Access Compliance Report

Public Rights-of-Way

Intersection ID: 49303	Main Street: ARDREY_CREST_DR	Cross Street: WADE_ARDREY_RD	Location: SW
ADA ID: 28530CF59874	Ramp Type: Perp	Initial Pass/Fail: Fail	Overall Compliance: No
Severity Score: 8.75			
Codes/Mitigation Info/Possible Solution		Field Measurements/Component Compliance

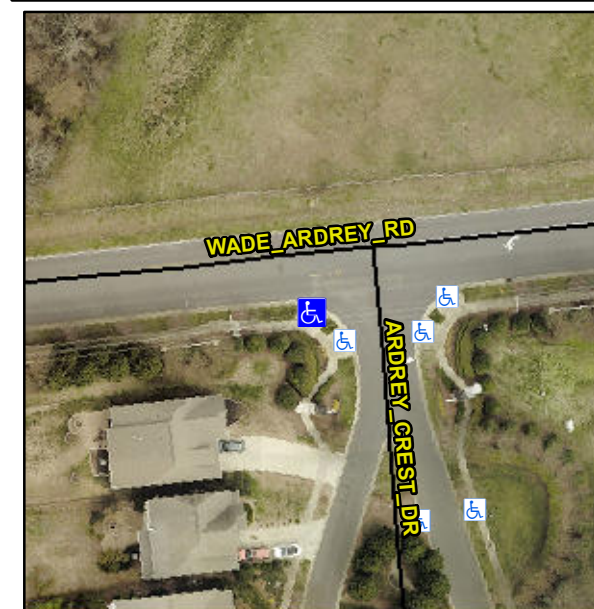
Not Found, R304.5.1

Compliance	Description	Data	Compliance	Description	Data
N/A	Ramp Length (in)	96.0	Yes	Ramp Slope (%)	5.6
No	Ramp Width (in)	47.0	Yes	Ramp XSlope (%)	1.2
N/A	Flare Type LT	N/A	N/A	Flare Type RT	N/A
N/A	Flare Slope LT (%)	N/A	N/A	Flare Slope RT (%)	N/A
N/A	Flare Traversable LT?	N/A	N/A	Flare Traversable RT?	N/A
N/A	Landing Length (in)	N/A	N/A	DWS Provided?	N/A
N/A	Landing Width (in)	N/A	N/A	DWS Contrast?	N/A
N/A	Landing Slope (%)	N/A	N/A	DWS Length (in)	N/A
N/A	Landing X Slope (%)	N/A	N/A	DWS Full Width?	N/A
N/A	Landing Curb? (Y/N)	N/A	N/A	DWS Offset (in)	N/A
N/A	Shared Landing?	N/A			
N/A	Gutter Ponding?	N/A	N/A	Gutter Slope (%)	N/A
N/A	Gutter Lip Ht (in)	N/A	N/A	Gutter X Slope (%)	N/A
N/A	Painted X Walk1?	No	N/A	Painted X Walk2?	N/A
	X Walk 1 Direction	To N		X Walk 2 Direction	N/A
N/A	X Walk 1 Width (in)	N/A	N/A	X Walk 2 Width (in)	N/A
	X Walk 1 Slope (%)	0.6		X Walk 2 Slope (%)	N/A
	X Walk 1 X Slope (%)	1.2		X Walk 2 X Slope (%)	N/A

Remove & Replace Entire Ramp.
